## Village of Greenport Building Department

### NOTICE OF DISAPPROVAL

PLEASE TAKE NOTICE that your application dated December 24, 2020 – with required documents received on January 7, 2021 - to make alterations to a 2-story building and an accessory structure at 511 Carpenter Street - is returned herewith and disapproved on the following grounds:

SITE PLAN

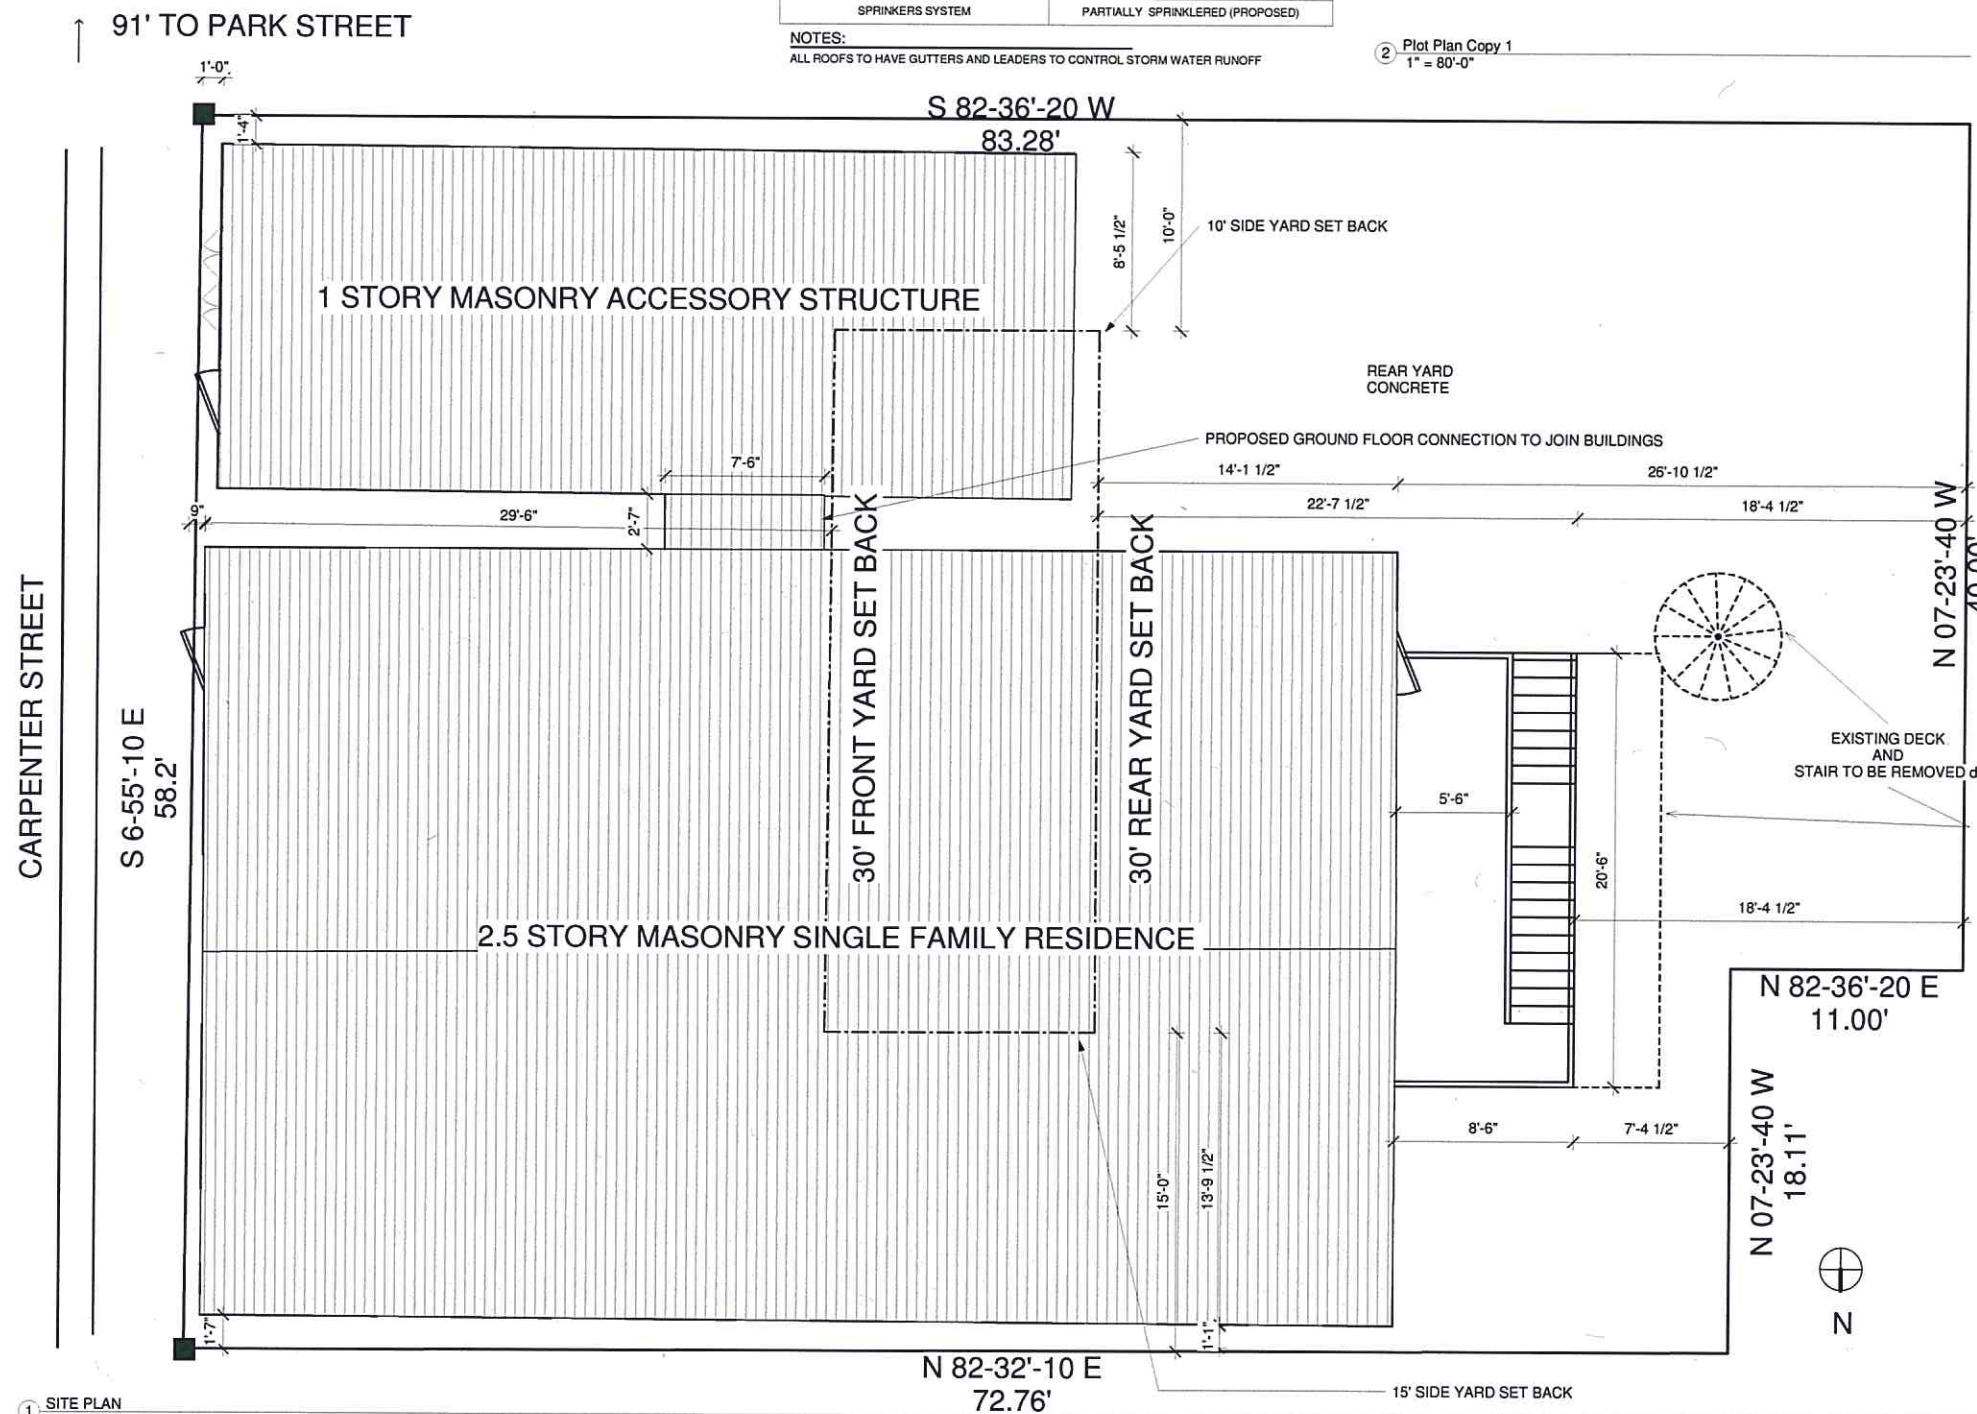
The plans show the lot coverage is 52%. This would require an area variance of 22% lot coverage increase.

The plans show the front yard of the 2-story building setback of 1-foot, 6-inches. This would require an area variance of 28-feet, 6-inches.

The plans show the front yard setback of 1-foot, 6-inches. This would require an area variance of 8-feet, 6-inches.

The plans show the front yard setback of 1-foot, 6-inches on the north side. And 3-feet, 4-inches on the south side. this would require an area variance of 20-feet, 4-inches.

The plans show the front yard setback of 5-feet, 6-inches. This would require an area variance of 24-feet, 6-inches.

The plans show an accessory structure measuring 18-feet. The maximum height allowed is 15-feet. This would require an area variance of 3-feet.

The plans show an accessory building located in the side yard. This would require an area variance for the accessory structure location.

The plans show an accessory structure measuring 3-feet, 4" on the front yard. This would require an area variance of 1-foot, 8-inches.

The plans show an accessory structure measuring 3-feet, 2" on the side yard. This would require an area variance of 1-foot, 10-inches
